**SUNDRY NOTICES AND REPORTS ON WELLS**  
*Do not use this form for proposals to drill or to re-enter an abandoned well. Use form 3160-3 (APD) for such proposals.*

C.P. Falby A & B  
Commingled Battery  
NE ¼ SW ¼ Section 8 T22S, R37E  
Battery 1 Lea County 71-033706

# Falby LACT Unit

**LACT Meter  
Conditions of Approval**

Add LACT unit to Battery  
LACT Circulation line to  
Production Header

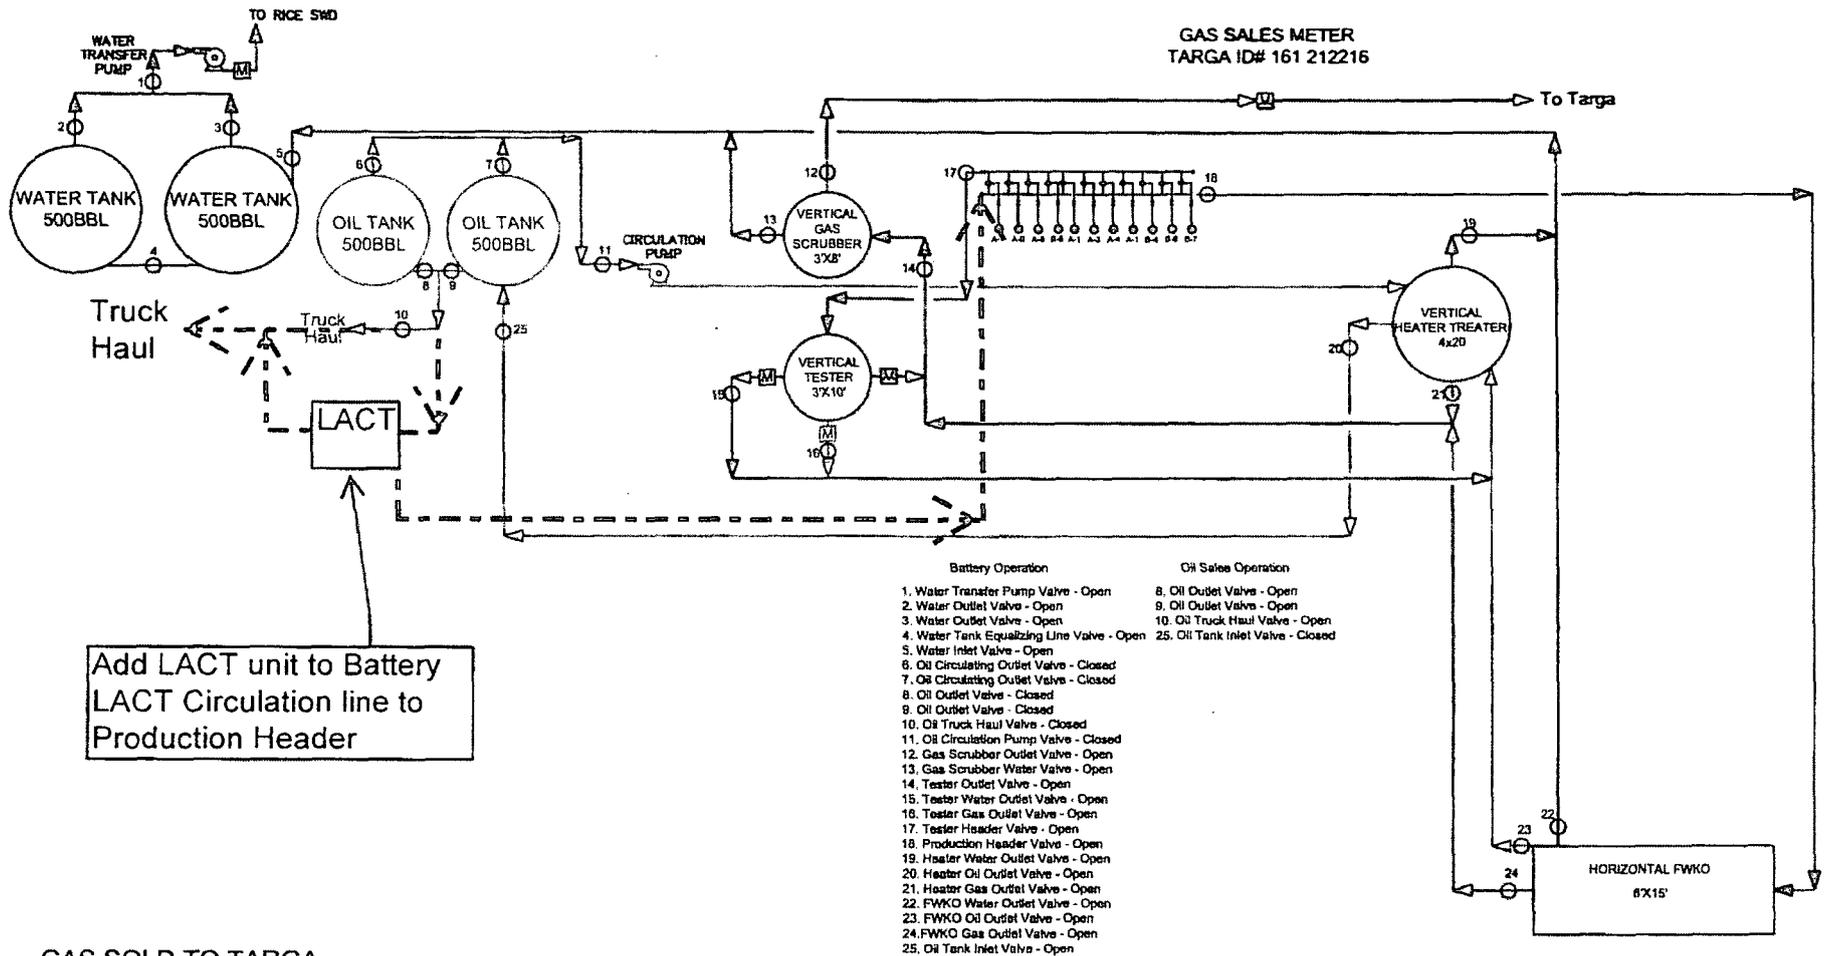
- GAS SOLD TO TARGA
- TURBINE METERS ON TEST SEPARATOR OIL, WATER AND GAS DUMPS
- OIL SOLD VIA TRUCK HAUL
- WATER DISPOSED VIA RICE SWD
